Well Name: SAKER 6-7 FEDERAL COM

Well Number: 12H

Type of Action: APD Change

Procedure Description: OXY USA INC., respectfully requests to amend the subject AAPD by revising the Well Name, SHL, BHL, TVD & Drill Plan as follows: Old Well Name: SAKER 6_7 FEDERAL COM 12H New Well Name: SAKER 6_7 FEDERAL 12H Old SHL: 200' FNL 1340' FWL New SHL: 200' FNL 1730' FWL Old BHL: 20' FSL 1657' FWL New BHL: 20' FSL 2257' FWL Old TVD: 10289' New TVD: 10369' Attached is the updated C102, Drill Plan, Directional Survey & APD Change Sundry Worksheet

Property Name	Well Number	Drawn By	Revised By
SAKER 6_7 FED	12H	R.J. 12-20-19	REV. 1 Z.T. 10-09-24 (SHL, WELLBORE AND FORMAT CHANGES)

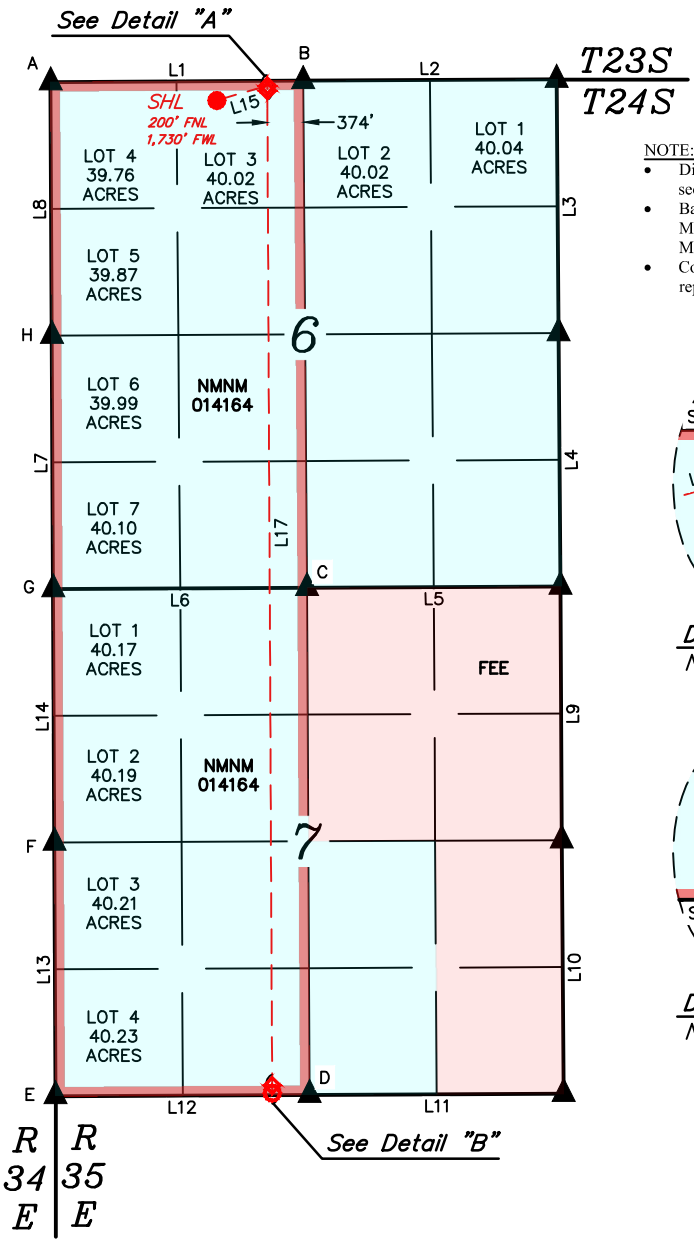
OXY USA INC., respectfully requests to amend the subject AAPD by revising the Well Name, SHL, BHL, TVD & Drill Plan as follows:

Old Well Name: SAKER 6_7 FEDERAL COM 12H
New Well Name: SAKER 6_7 FEDERAL 12H

Old SHL: 200' FNL 1340' FWL
New SHL: 200' FNL 1730' FWL

Old BHL: 20' FSL 1657' FWL
New BHL: 20' FSL 2257' FWL

Old TVD: 10289'

New TVD: 10369'
